g0-sense — Design Document

ai-ee v1 pipeline
generated 2026-08-27 15:59:48

P4 schematic waivers - g0-sense

W2 - carried SHT4x VDD-slew verify item - CLOSED as accepted risk

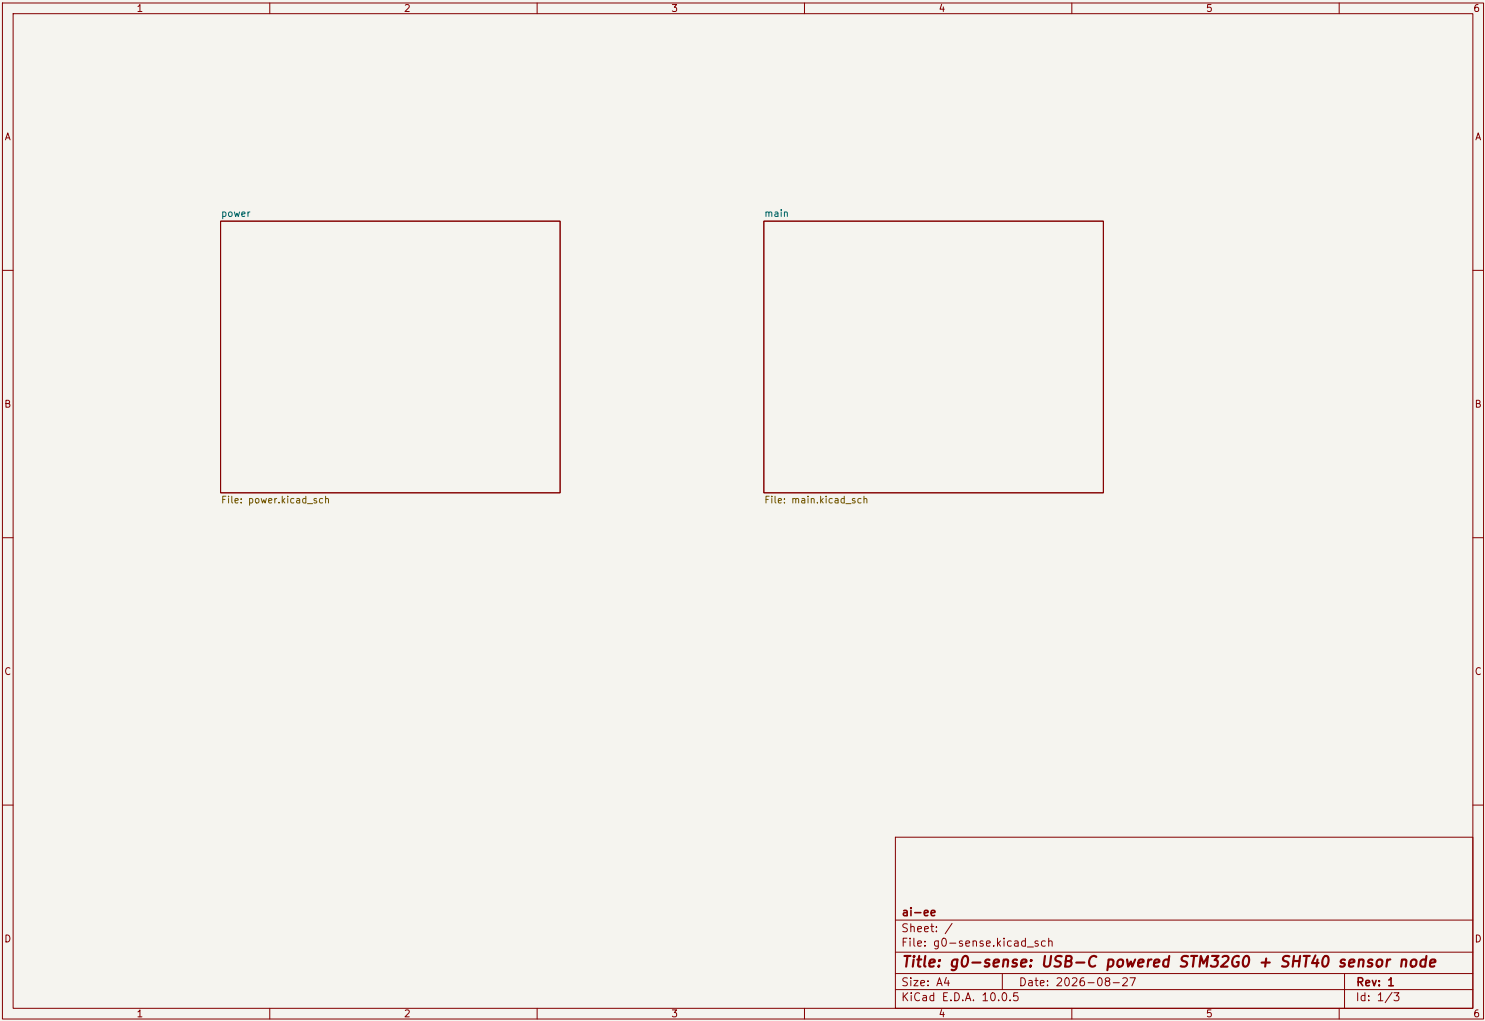
Finding: `power_tree.md` / `decisions.md` carried "verify SHT4x VDD slew ≤ 20 V/ms vs the AMS1117 startup ramp"; the reviewer found it unclosed, found no slew spec in `parts/C2909890.json`, and computed ~ 40 V/ms from AMS1117 current-limit charging of the ~ 27 uF on +3V3.

Closed, no hardware change, on three findings:

1. **Provenance is on file** (the reviewer looked in the wrong artifact). The number is `research/records/sht4x-vdd-slew-power-up.yaml`, sourced to `research/sources/HT_DS_Datasheet.SHT4x.pdf` p9 Table 4, read visually by the researcher and again by a fresh second reader (`maturity: verified`). `parts/C2909890.json` is the P3 extraction, a different artifact with a different scope.

2. **The worst-case number is an upper bound that cannot occur.** I/C (~ 1 A into ~ 27 uF) assumes the LDO drives its output cap independently of its input. The AMS1117 is a series-pass follower: on a cold start VOUT cannot rise faster than VIN minus dropout, so the +3V3 edge is set by the USB source's VBUS ramp filtered by $C2 = 10$ uF, not by the LDO's current limit.

3. **The named failure mode is benign at cold start.** The datasheet says only "faster slew rates MAY lead to a reset" - and the second reader already flagged the researcher's added "or hung until re-powered" as unsupported by any cited page. A reset during the power-up ramp leaves the part in exactly the state a power-up is meant to produce. The limit's real bite is in-operation supply excursions, and hot-plugging a DOWNSTREAM breakout onto an already-live Qwiic rail - that one is the breakout's decoupling problem, not this board's.

Hardware alternatives considered and rejected: a series R at U3 VDD to slow the local ramp is disqualified by the SHT4x on-chip heater (75 mA peak across the ~ 100 ohm needed for a 100 us $\tau = 7.5$ V drop); raising C3 past ~ 50 uF to force I/C under 20 V/ms buys nothing against finding 2 and costs a part change on a green schematic.

Belt and braces, documentation only: "issue an SHT4x soft reset (0x94) at init" (Sensirion's own recommended start-up sequence) goes into the design doc and **fab/README**, and the Qwiic hot-plug caveat is carried as a known limit of the board.
